Re: Comment Response to City of Portland Peer Review Engineer
Harborview Development, LLC – 121 York Street

On behalf of the project team Acorn Engineering, Inc. is pleased to respond to the comments provided by the City Peer Review Engineer dated June 23rd, 2011 by David Senus, P.E. and Ashley Auger, E.I.T. of Woodard & Curran.

EXISTING CONDITIONS SURVEY PLAN
AT 127-129 YORK STREET, PORTLAND, MAINE
FOR HARBORVIEW DEVELOPMENT LLC

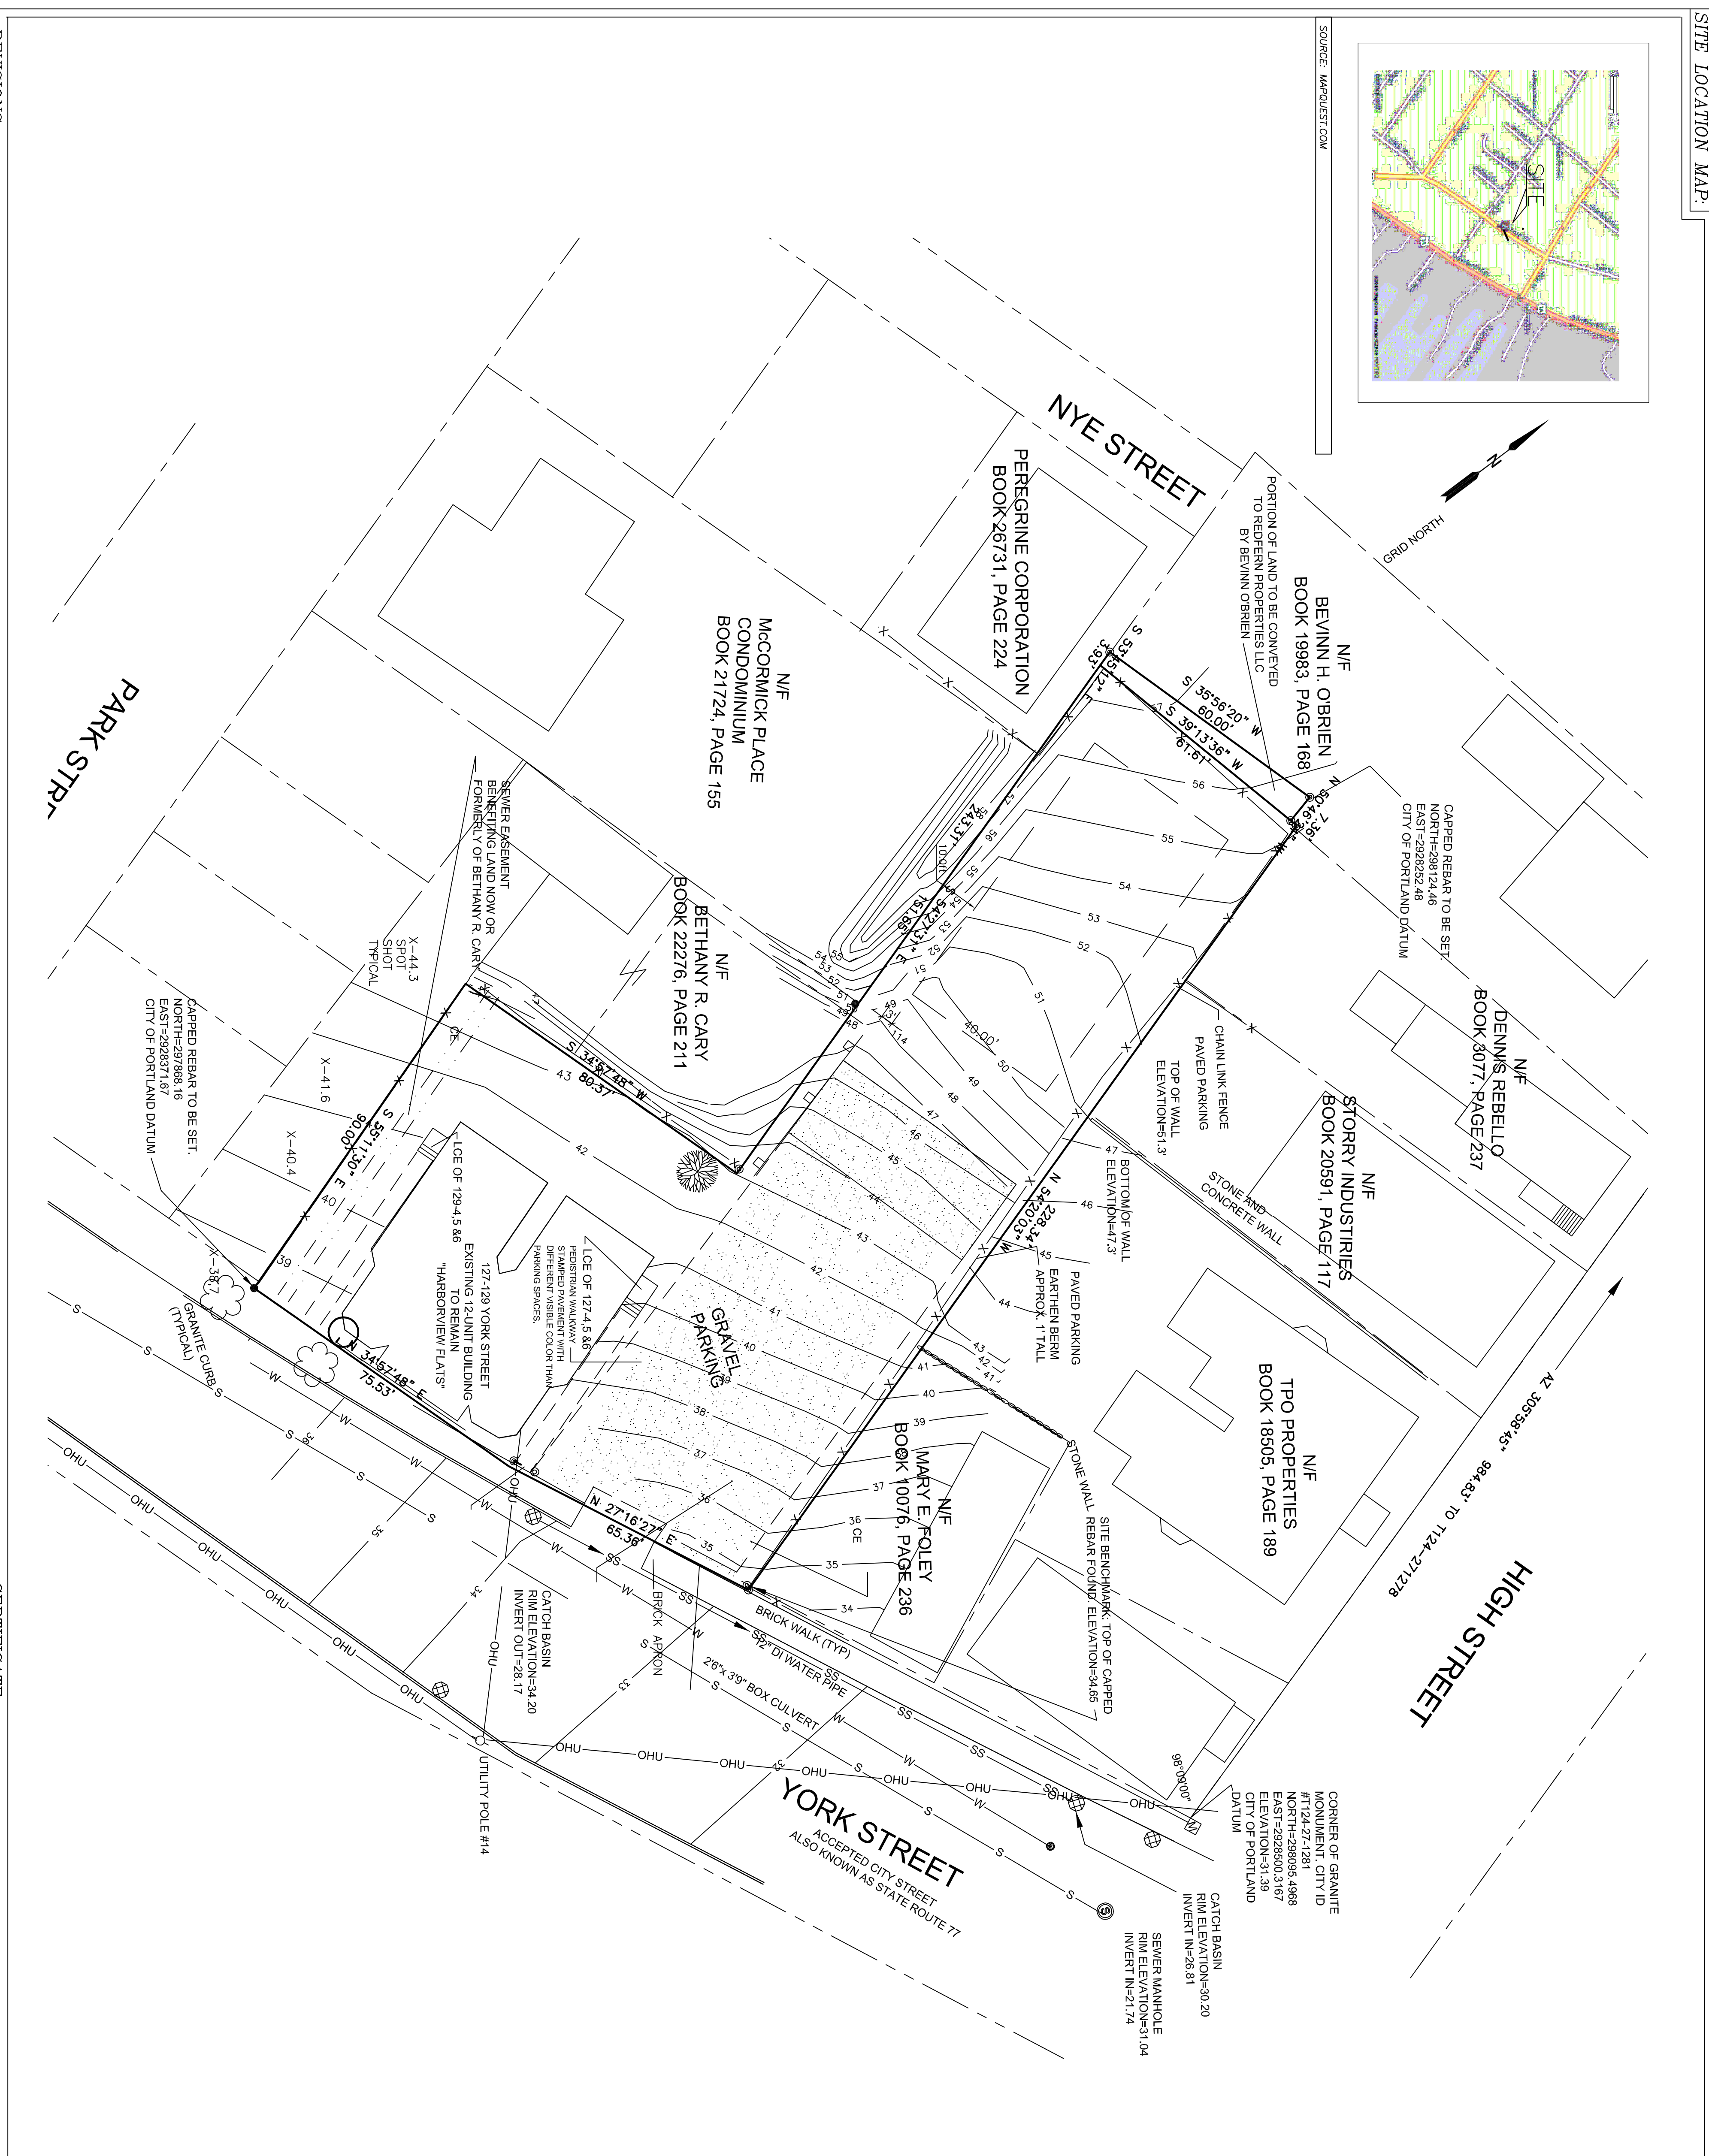
- 1. In the Applicant's response to comments letter, an explanation was provided on how the proposed grading will match into adjacent, existing conditions; however, this is not clearly presented on the most recent plans. Proposed contours along the majority of the perimeter of the property are not shown to connect to existing contours. Additional clarification is needed on the plans, especially along the eastern side of the property and the northwest portion of the parking lot.*

The project team requested Ocean Park Land Surveying, Inc. provide additional information regarding the existing contours and the presence of retaining walls both on and abutting the property. The revised survey provided some additional information on how the existing contours within the parcel connect to the abutting parcels along the eastern property line. Please refer to the Existing Conditions Survey Plan from Ocean Park Land Surveying, Inc.

TITLE:
 SITE PLAN

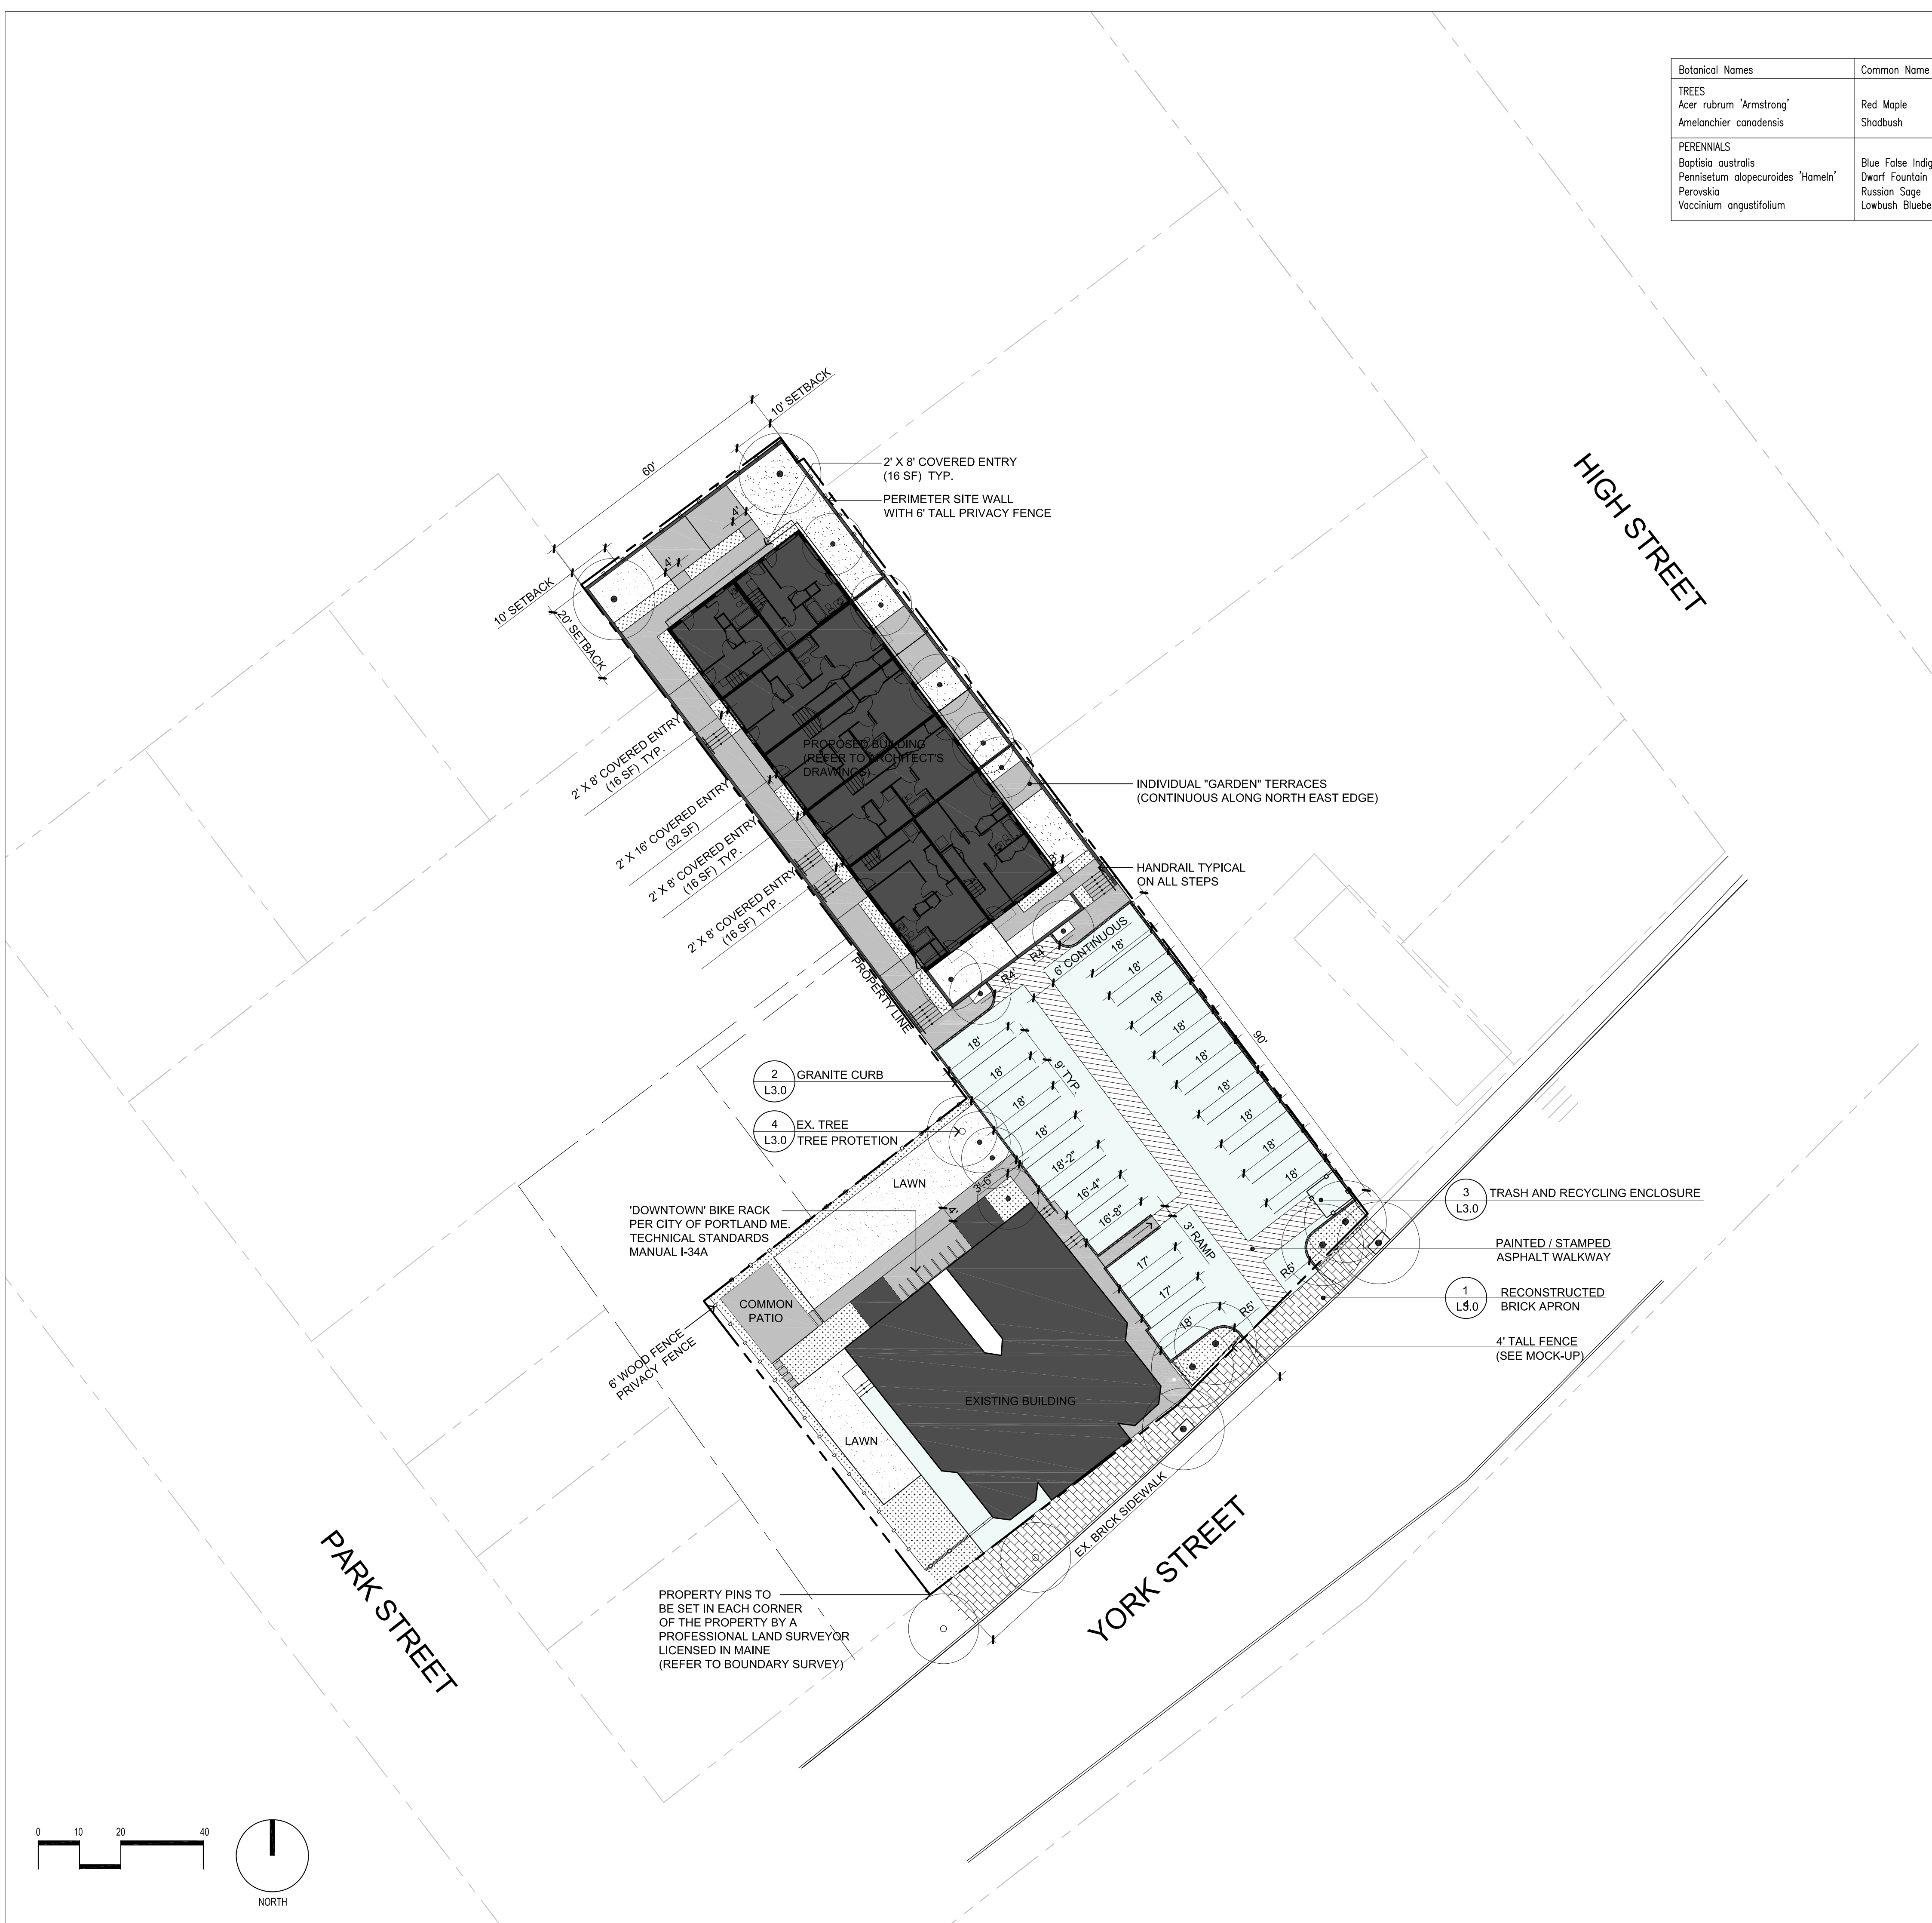
3. *The updated plans still do not provide clarity to the location and type of proposed curbing and sidewalks within the site.*

Response: Please refer to Soren Deniord Design Studio's - Site Plan for the location of granite curbing. To facilitate your review the curbing linetype was darkened and depicted within the symbols legend. Refer to Soren Deniord Design Studio's – Landscape Details for curbing within the reconstructed brick driveway apron.
